In the Matter of  
Wisconsin Electric Power Company  
(Point Beach Nuclear Plant, Unit 1)  
Docket No. 50-266 (OLA-2)

DOCKET NO. 30-266  
STEAM GENERATOR REPAIR  
POINT BEACH NUCLEAR PLANT, UNIT 1

LICENSEE'S RESPONSES TO QUESTIONS IN  
THE MARCH 22, 1983 APPEAL BOARD ORDER

Fig. 1. Illustration of major steps involved in full depth tube to tubesheet expansion process.

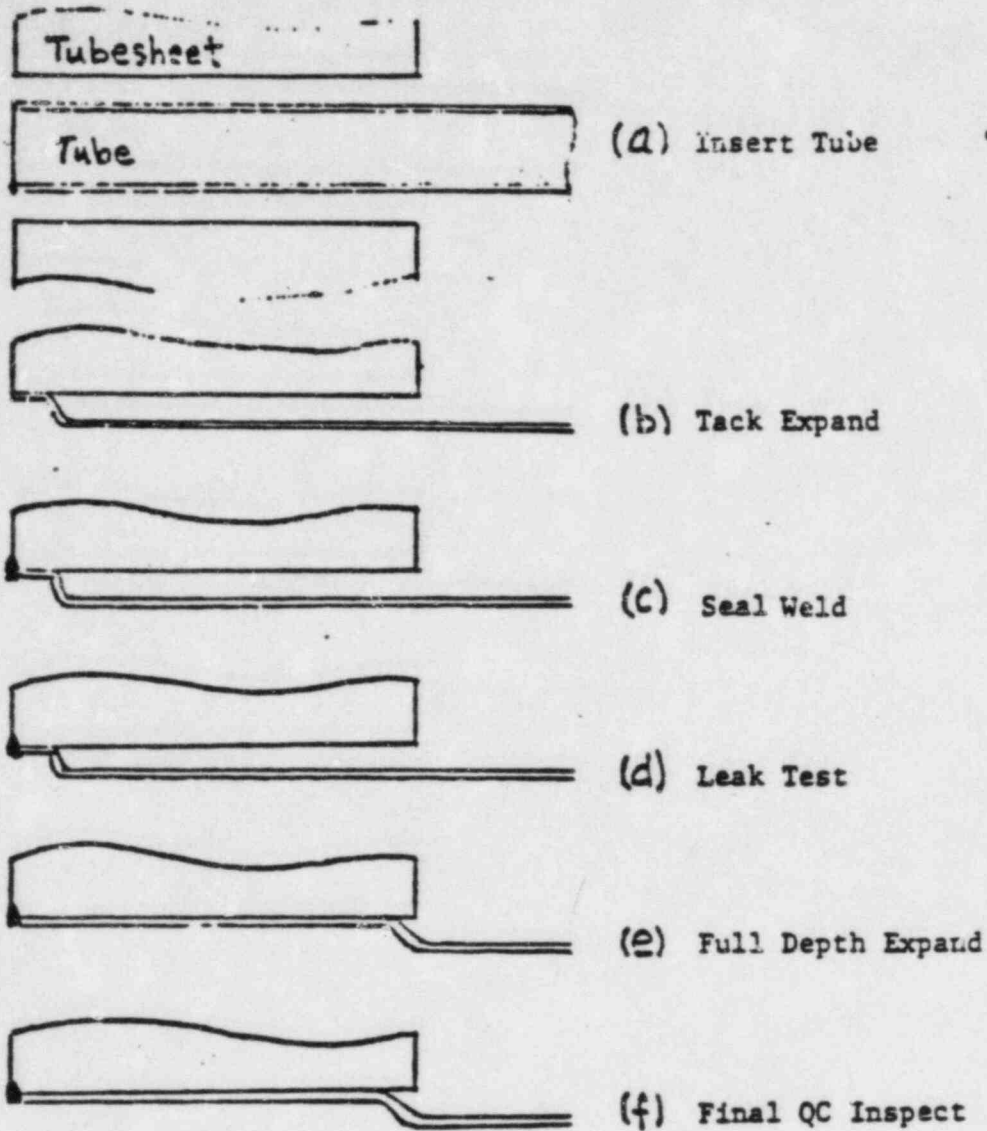
The main steps associated with each expansion process are depicted schematically in Fig. 1, and include:

Following the tubing process (insertion of tubes through support plates and tubesheet) the tubes are tack expanded for a depth of about 3/4" on the primary side to facilitate tube to tubesheet welding. Tack expansion is accomplished with either mechanical rolling or urethane expansion. The tube to tubesheet weld (actually tube to tubesheet cladding) serves as both a seal weld, preventing leakage between primary and secondary sides, and a strength weld, supporting the service imposed loads. After leak testing of the welds, the tubes are full depth expanded.

Fig. 3. Hydraulic expansion transition zone profile schematic at top is at 13X magnification. Traces at bottom are actual radial profile traces from a recent production unit.

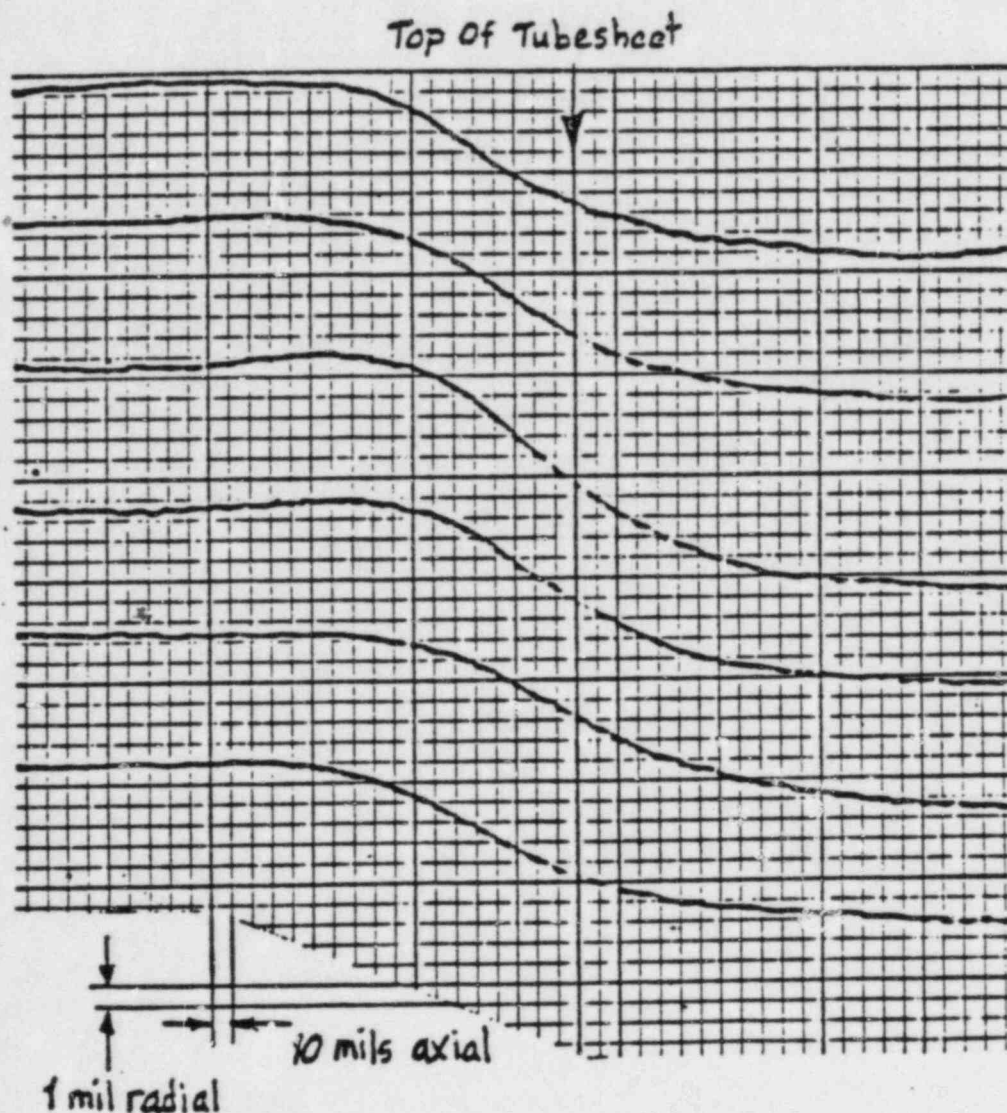
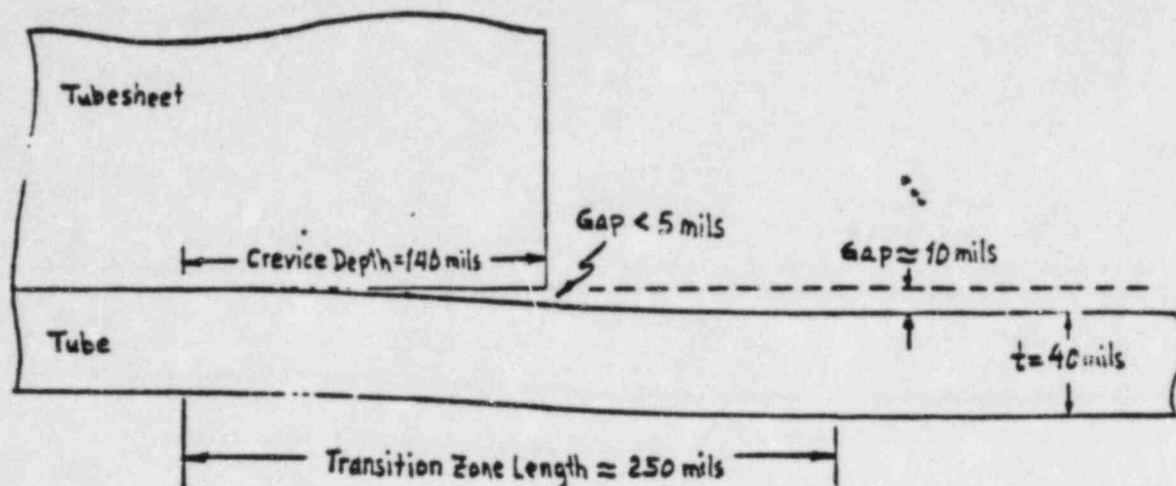
A typical hydraulic transition zone profile is shown in Fig. 3. The transition zone length is usually 0.25 to 0.3 inch long.

Fig. 4 Illustration of how residual stresses are determined by stress corroding cracking tests.

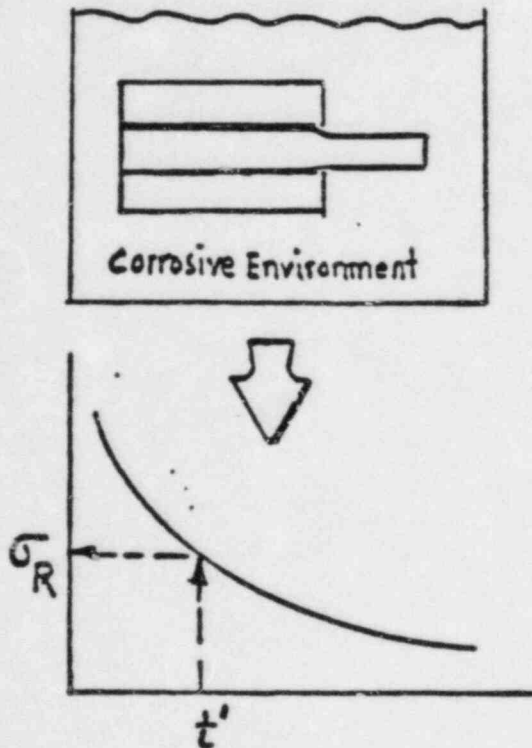
The test can be made quantitative by calibration. For this purpose, specimens of sensitized tubing are stressed to various known applied stress levels (no residual stresses) and tested in the corrosive environment as depicted in

Fig. 4. The specimens may be uniaxial tensile specimens but more often are C-ring specimens loaded to a given outer fiber stress. The results give a curve (called C-ring curve for C-ring specimens) of applied stress versus time to crack initiation. Samples having only residual stresses are then prepared and tested. Using the time to cracking, the C-ring or calibration curve is entered at that time to determine the magnitude of the residual stress as depicted in Fig. 4.

Fig. 5 Relative comparison of residual stresses for various expansion processes. Though stress and time scales are given to provide perspective, the figure is intended to be more schematic than quantitative.

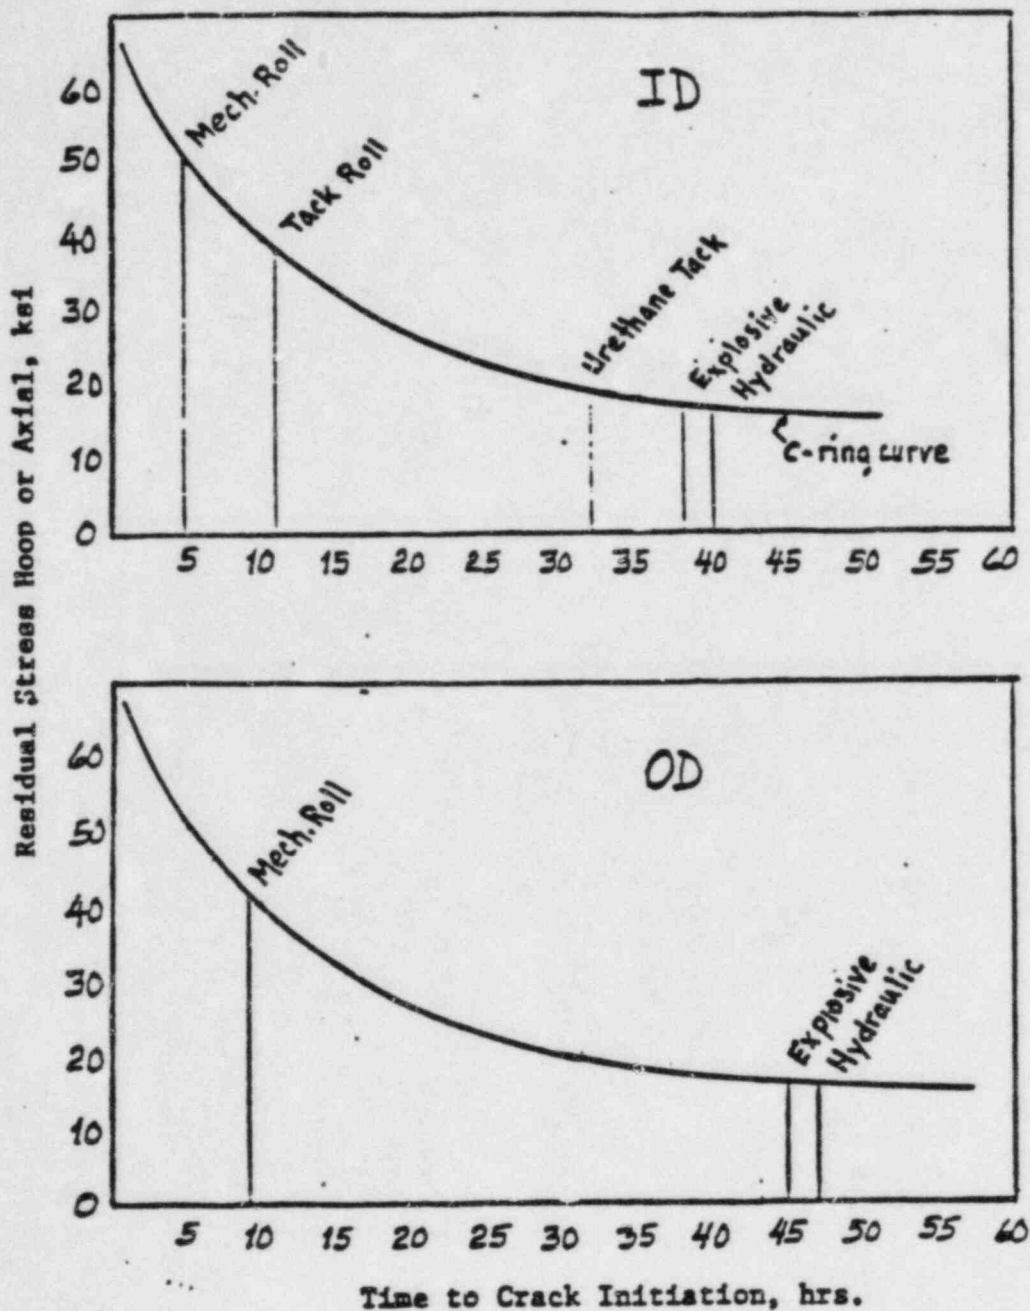
A comparison of the ID residual stresses at the tack expansion transition is also shown in Fig. 5 for soft (low torque) tack rolling and urethane tack

expansion. The residual stresses are much lower for urethane tack expansion, which is the process currently used at Westinghouse.

Fig. 6 Results of finite element analysis of residual stresses in hydraulically expanded transition.

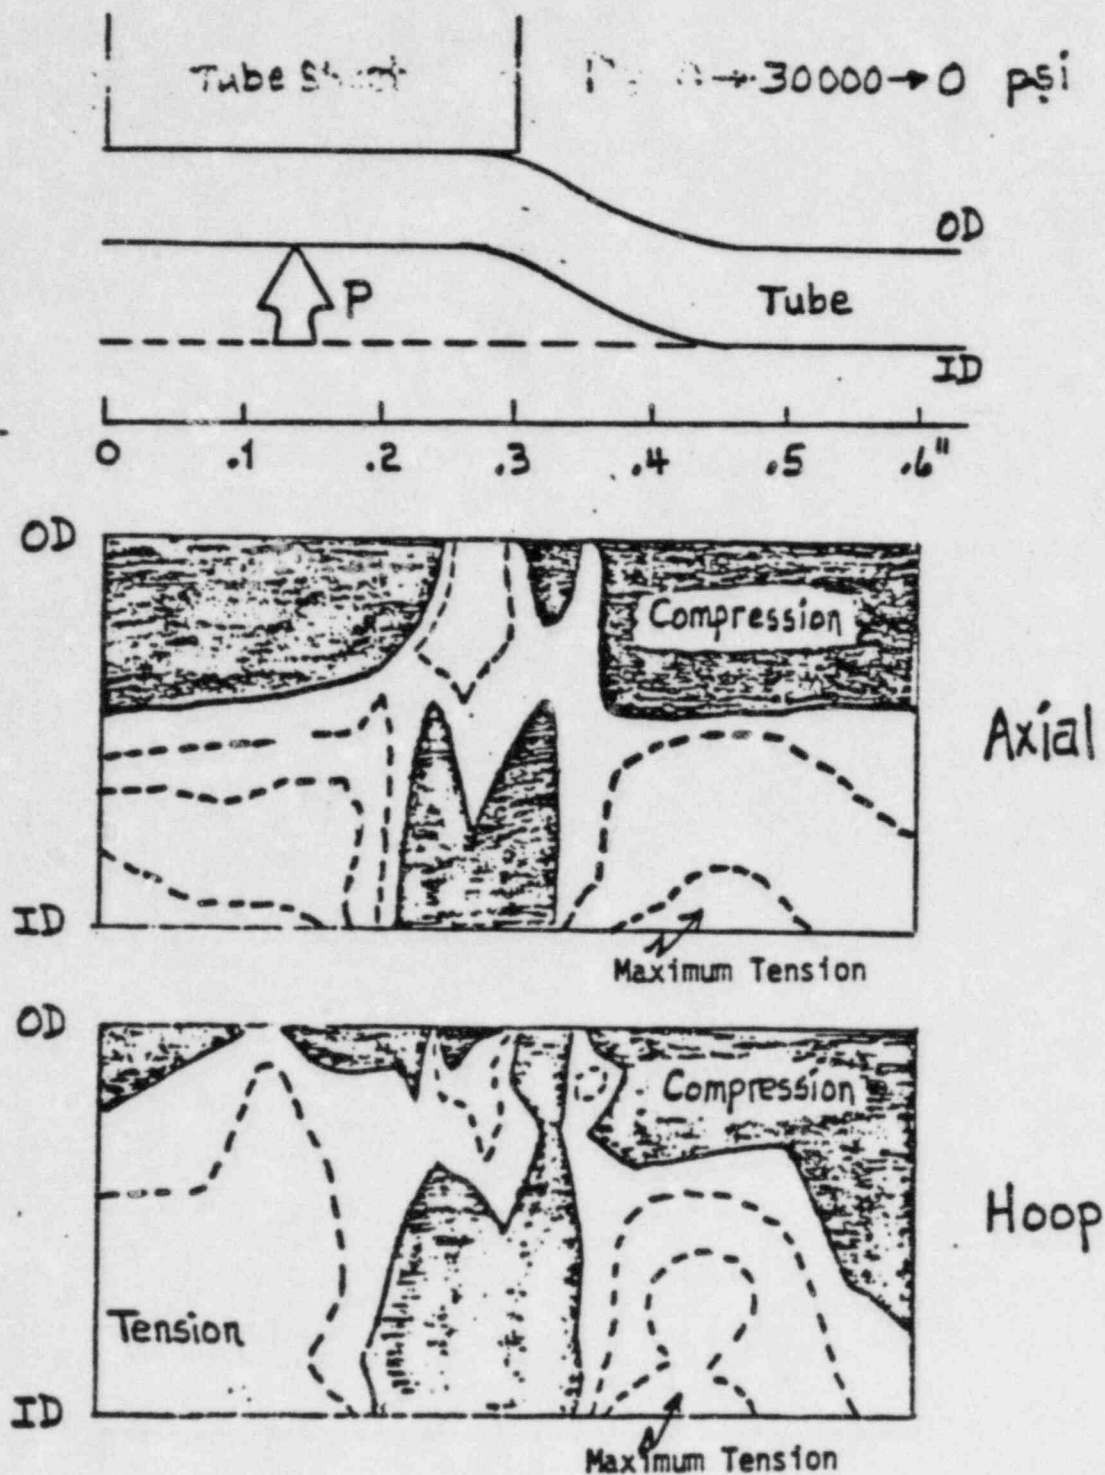
Inconel 600 Westinghouse Steam generator tubing is specially thermally treated to impart enhanced corrosion resistance. Tube expansion must not degrade this corrosion resistance. Intuitively, it might be reasoned that hydraulic expansion would have the least effect. Test results confirm that hydraulic expansion does not degrade the inherent corrosion resistance of the thermally treated tubing.
